# ADMINISTRATIVE AMENDMENT

**PROJECT NUMBER:** PR-2020-006070  
**APPLICATION NUMBER:** SI-2021-01889

<b>ENGINEER'S SEAL</b> 	<b>TITAN 150K SPEC BUILDING ALBUQUERQUE, NM</b> <b>SITE PLAN FOR BUILDING PERMIT</b> <b>TIERRA WEST, LLC</b> 5571 MIDWAY PARK PL NE ALBUQUERQUE, NEW MEXICO 87109 (505) 858-3100 www.tierrawestllc.com	<b>DRAWN BY</b> pm <b>DATE</b> 5-3-2022 <b>DRAWING</b> 2020088-150K.DWG <b>SHEET #</b> SP-1 <b>JOB #</b> 2020088
----------------------------	--	---

TITAN 150K SPEC BUILDING  
ALBUQUERQUE, NM

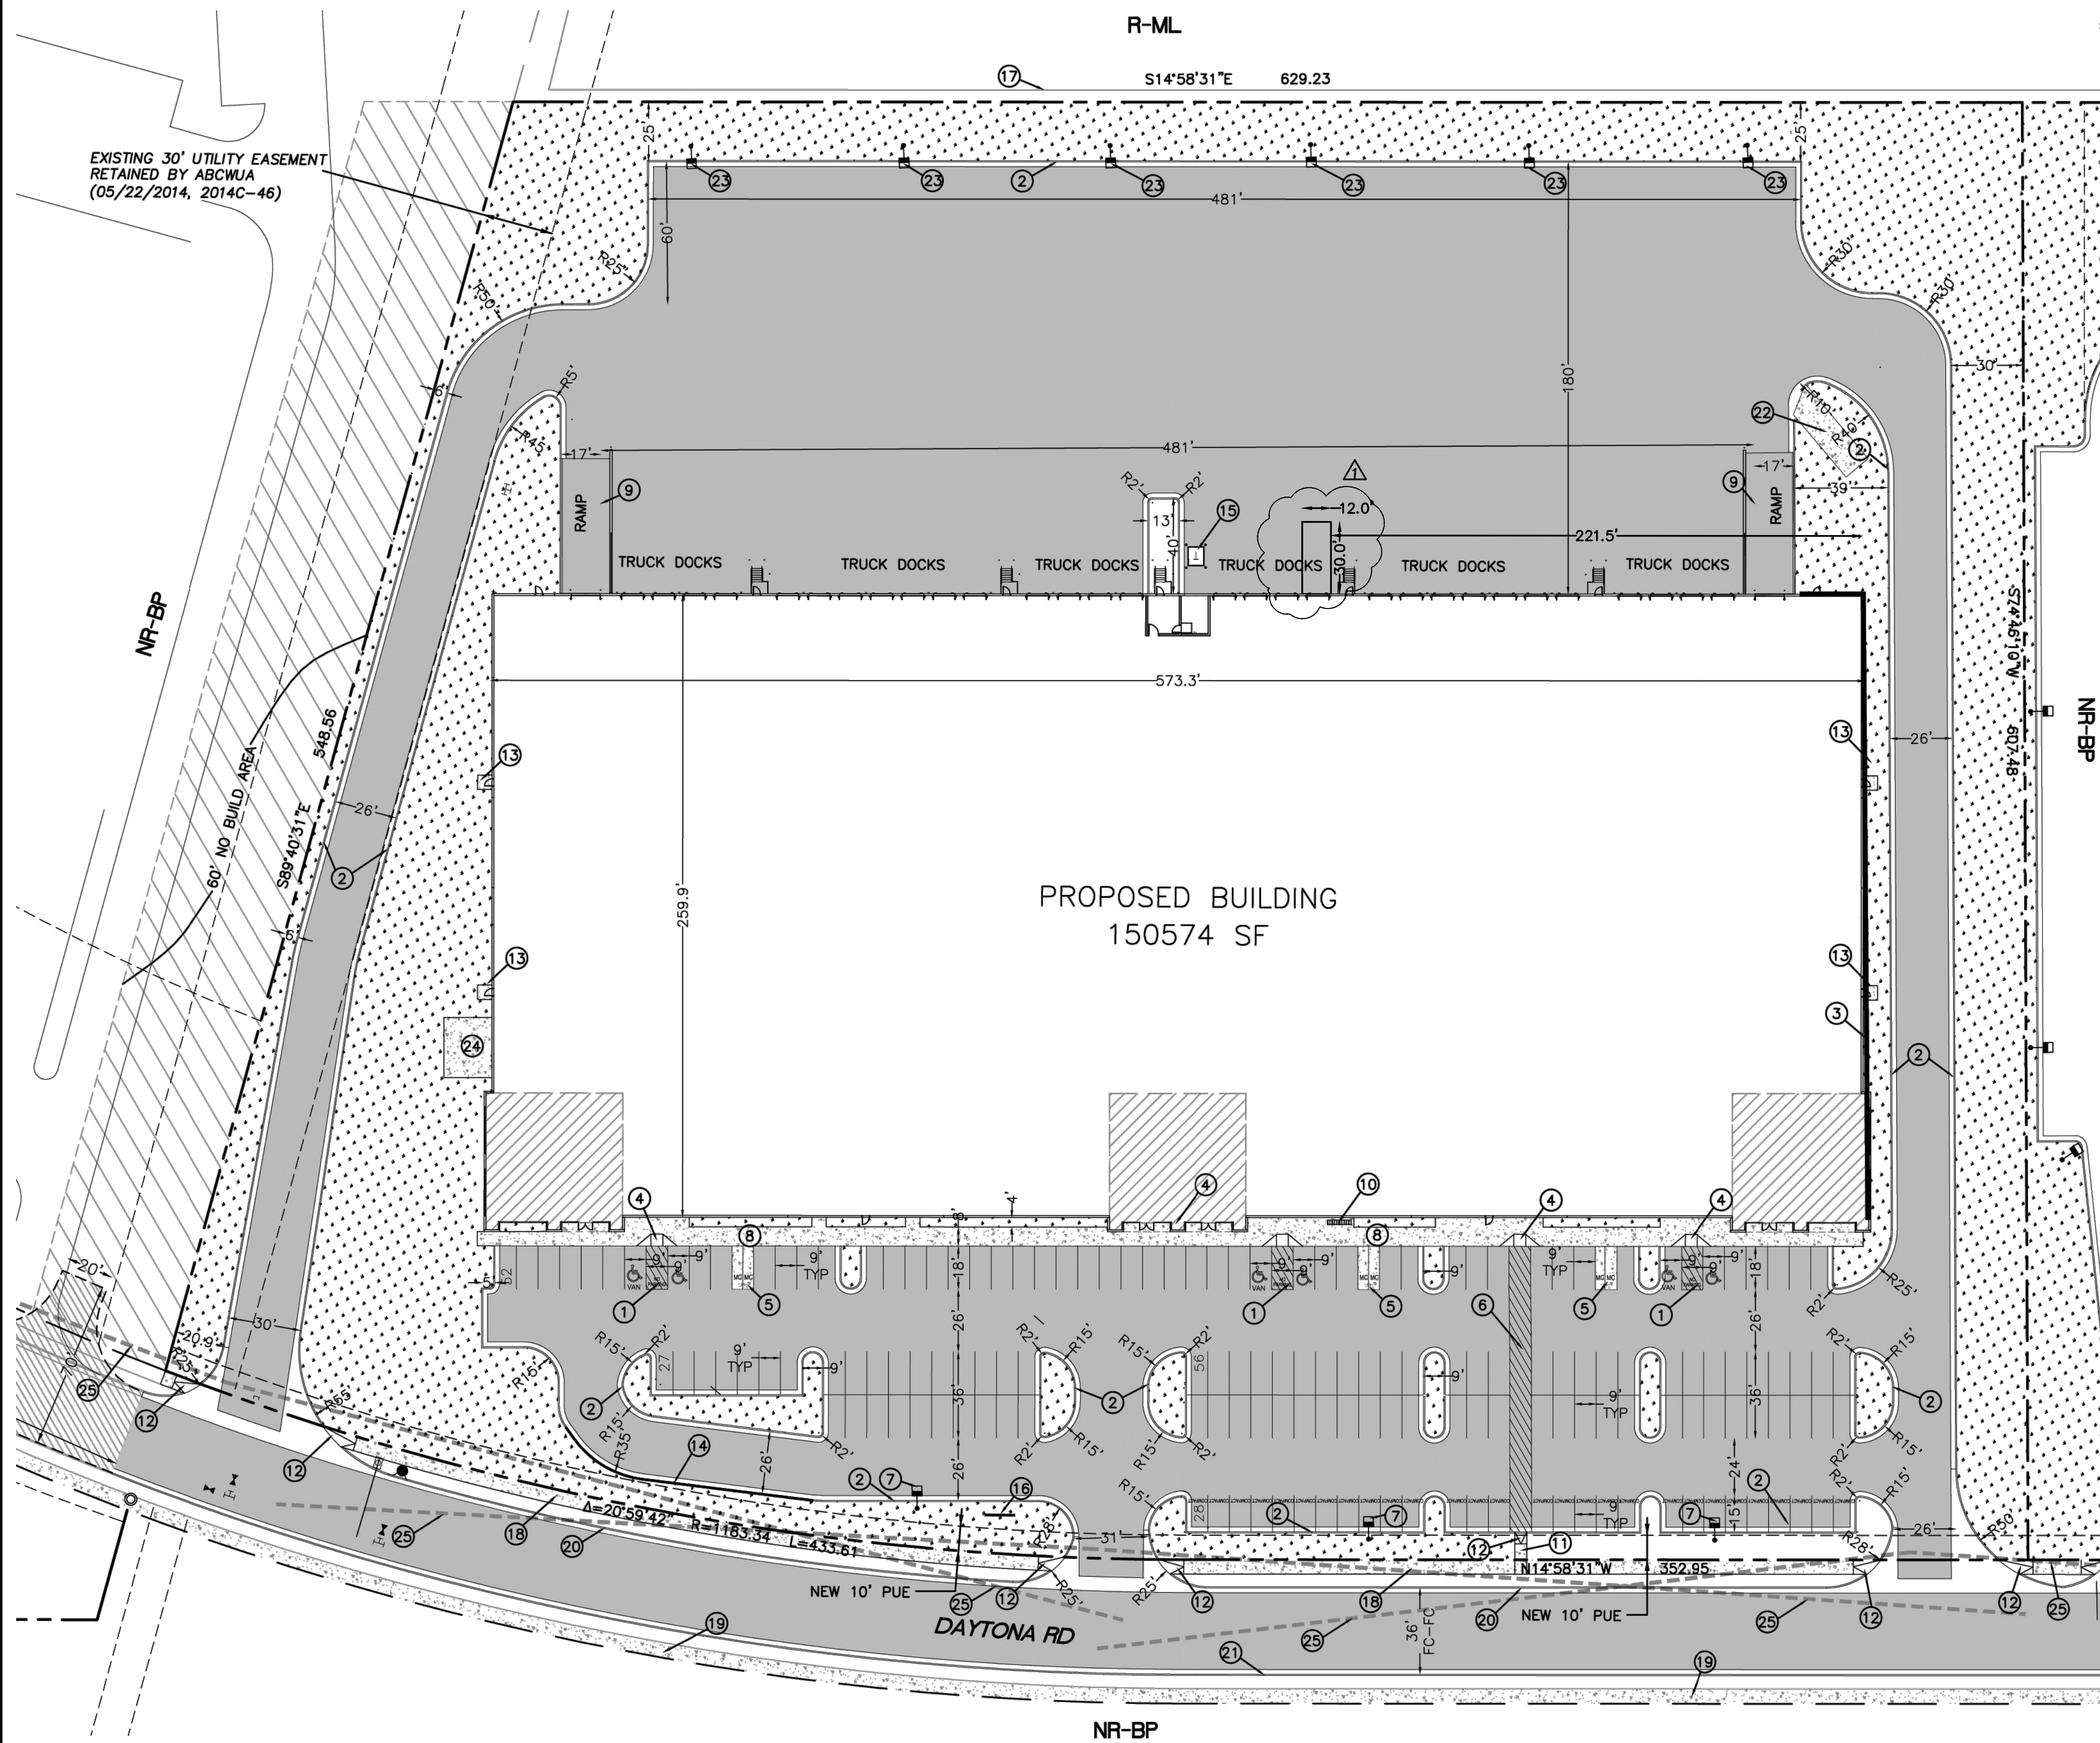
NO.	DATE	ADDED NEW WAREHOUSE RAMP	REMARKS	BY
1	6-13-24			pm
				BT

GRADING AND  
DRAINAGE PLAN

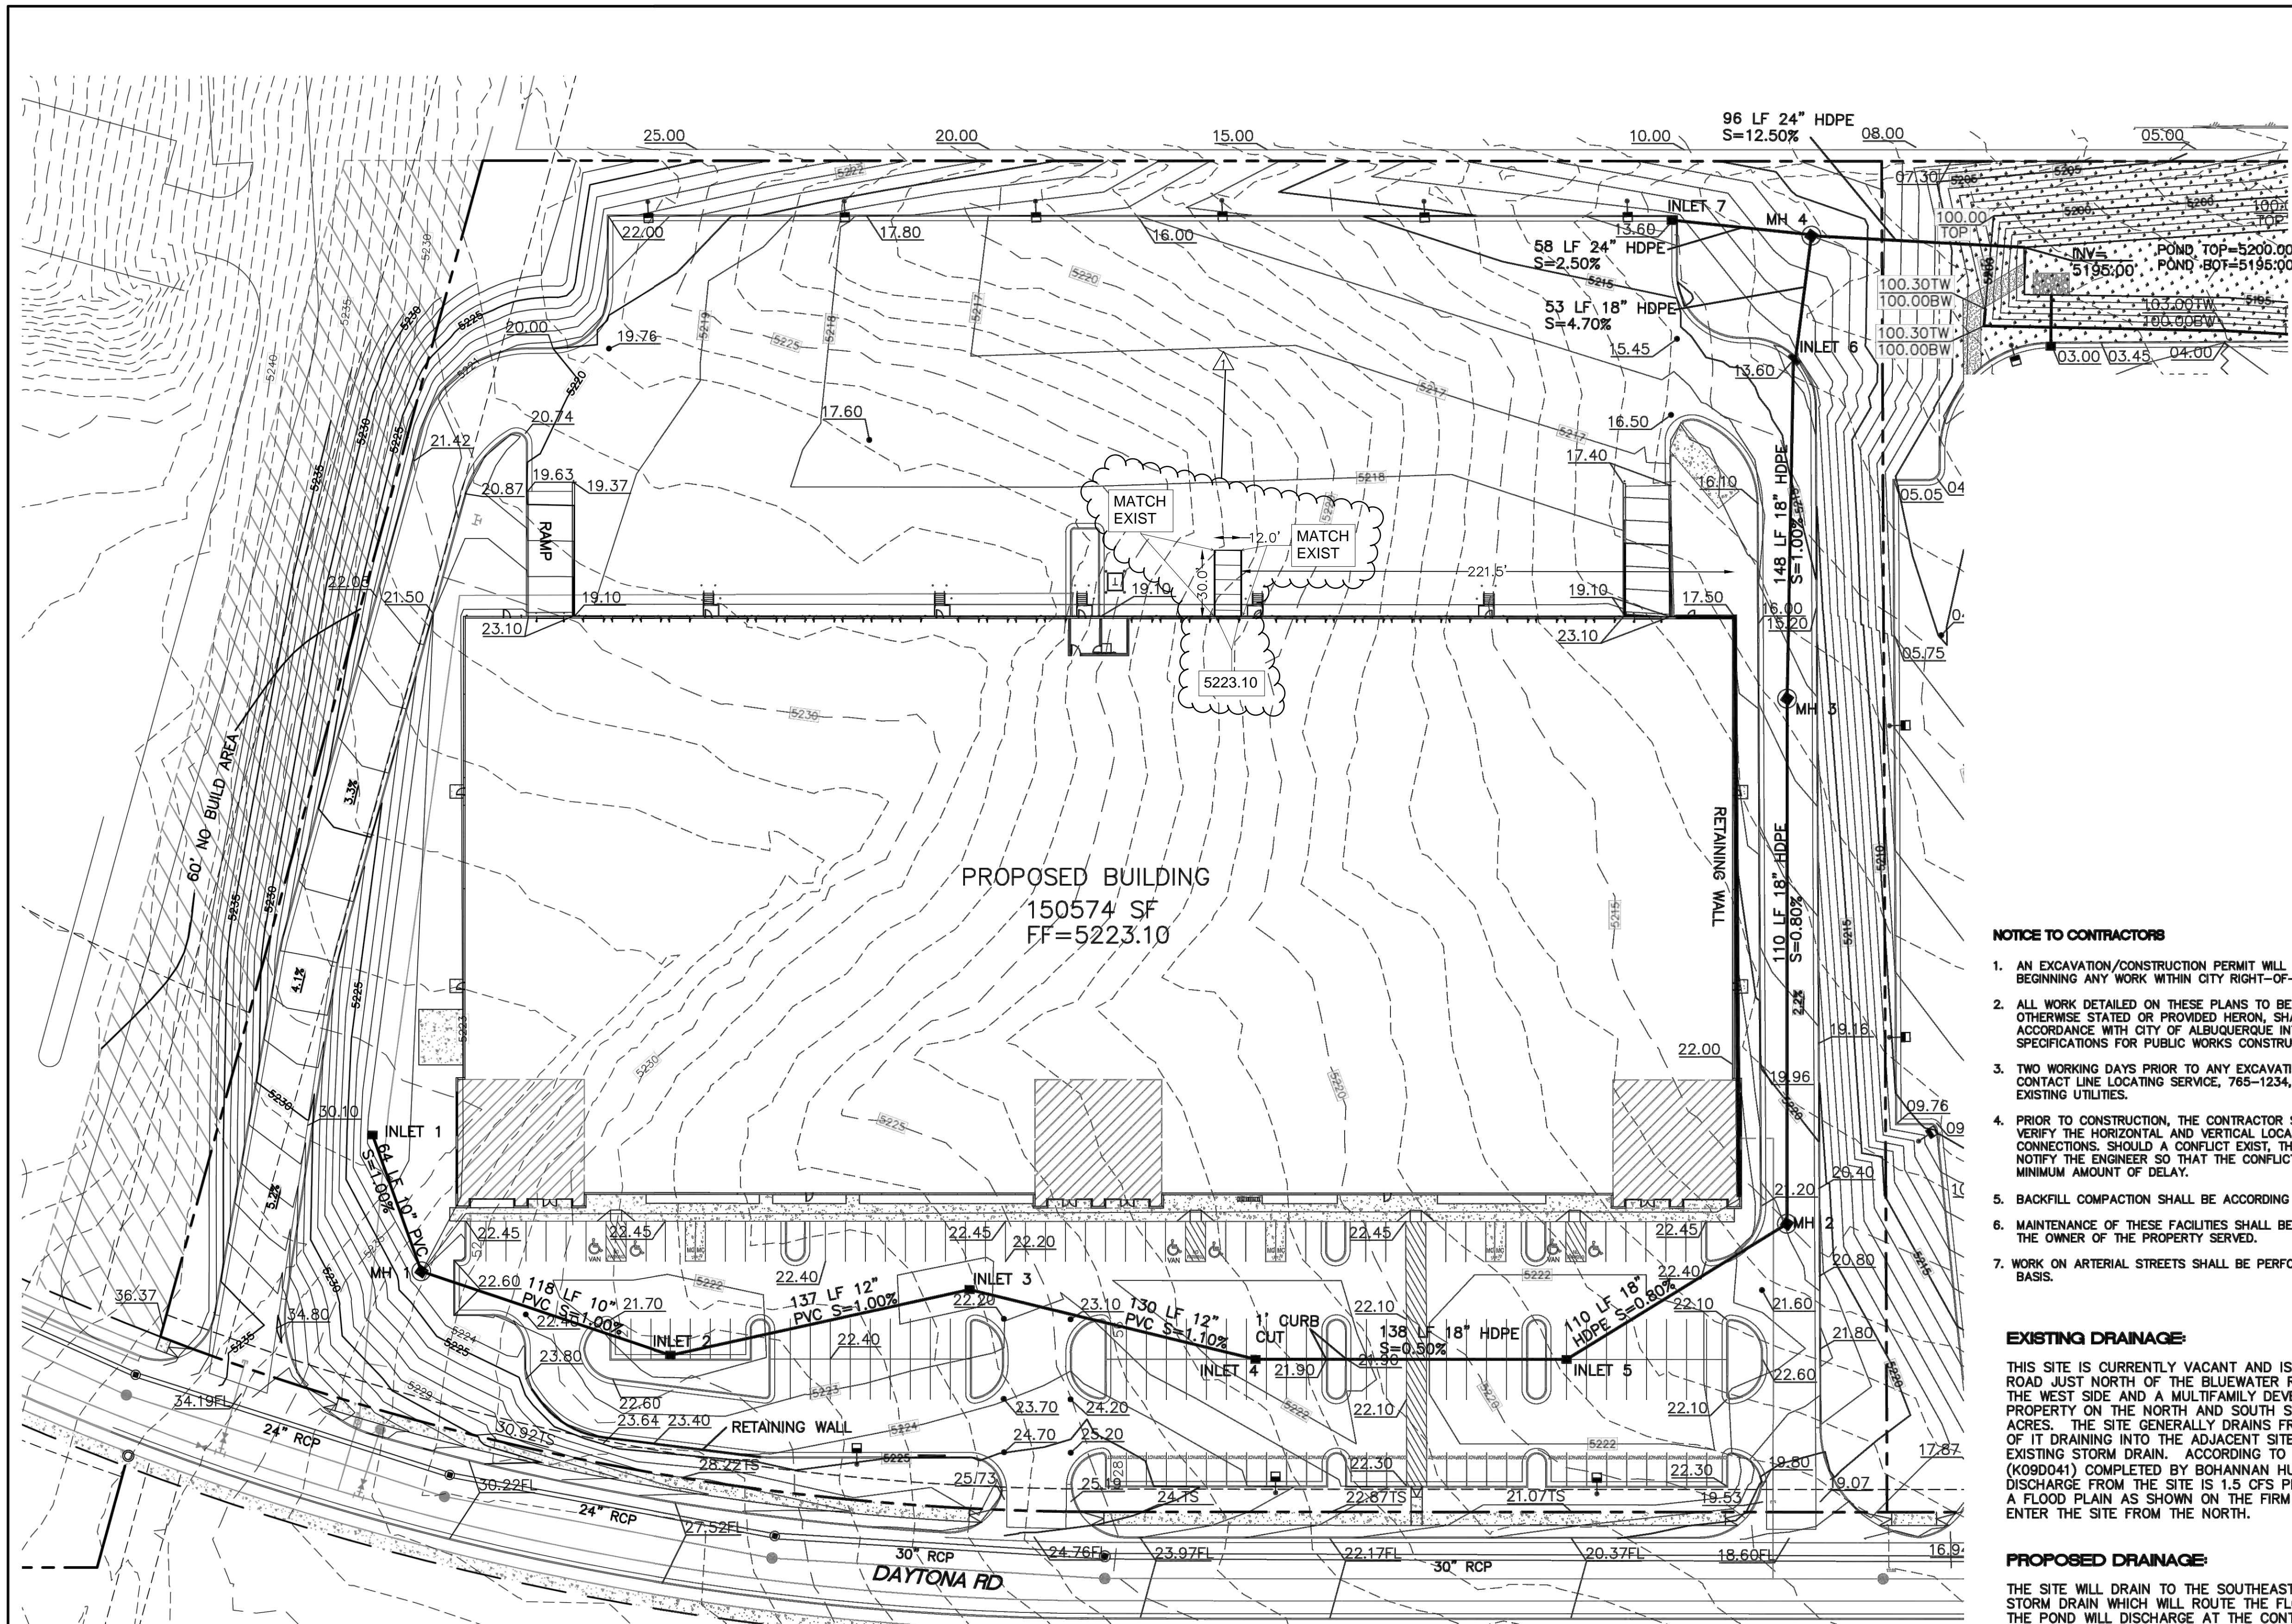
NO.	DATE	REVISIONS	BY
1	6-13-24	ADDED NEW WAREHOUSE RAMP	pm
